CONTRACT CHANGE ORDER NO. _____
 SHEET _____ OF _____

SAS SUPERSTRUCTURE AND SKYWAY STRUCTURE GIRDER INTERFACE EASTBOUND SERVICE PLATFORM #9W
 SCALE AS NOTED

E-186D

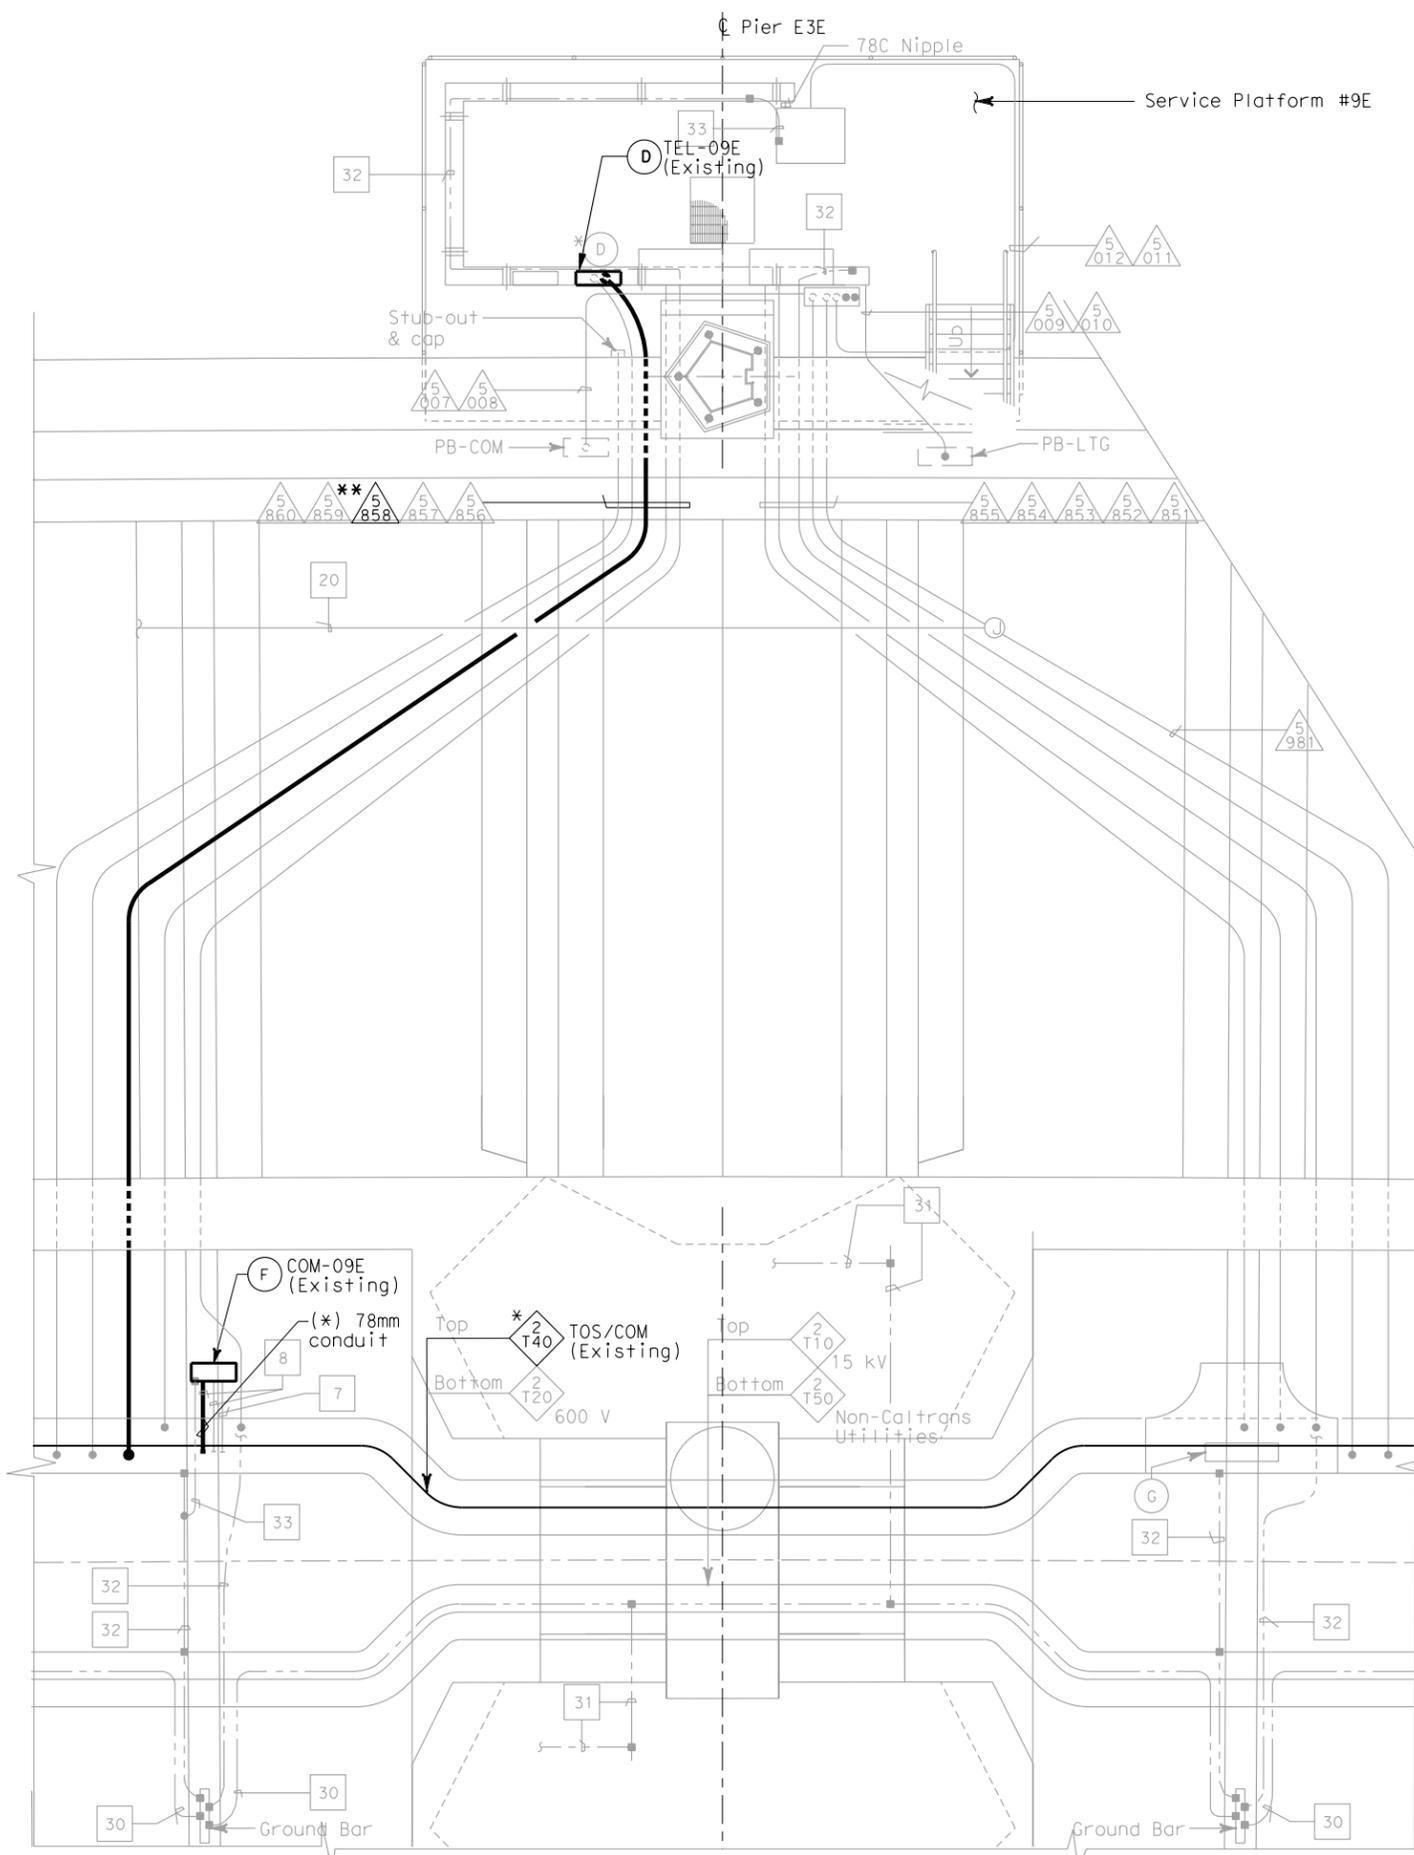
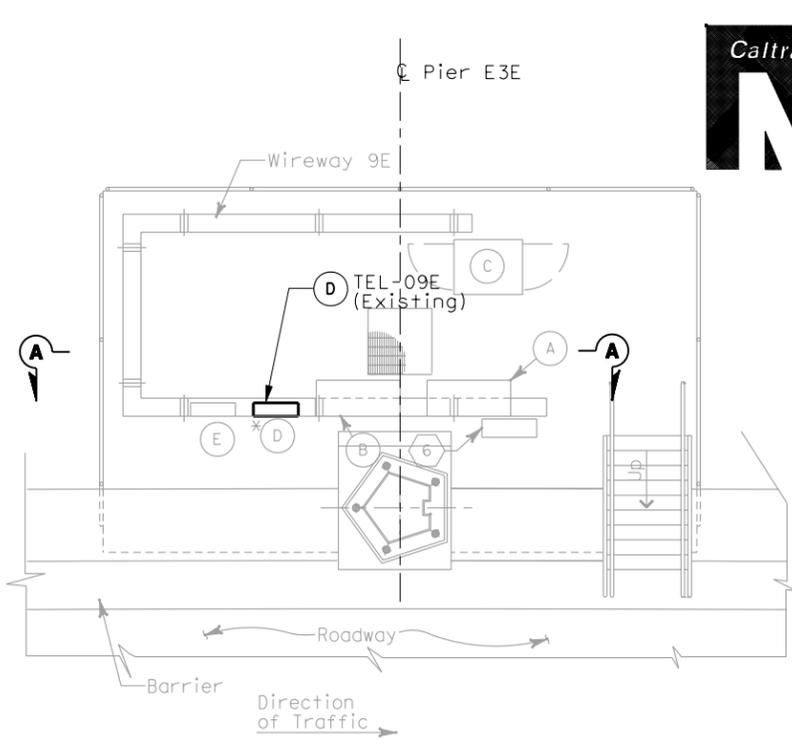
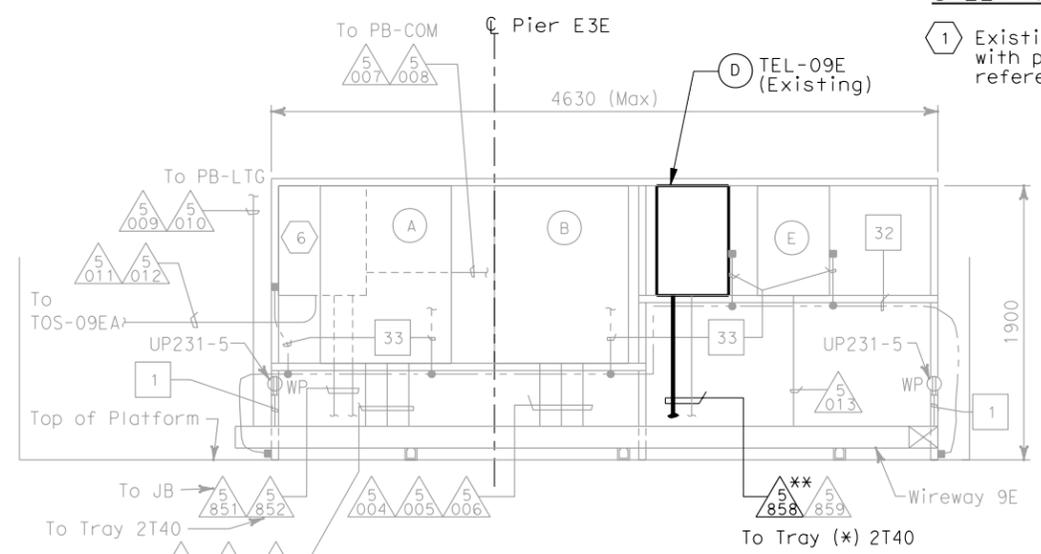
REQUEST FOR INFORMATION NOT ADDRESSED IN THIS CCO REMAIN IN FORCE					
△	02/25/08	CABLE TRAY CHANGES	JD	RG	42S1
MARK	DATE	DESCRIPTIONS	BY	CH'D	CCO#
		REVISIONS
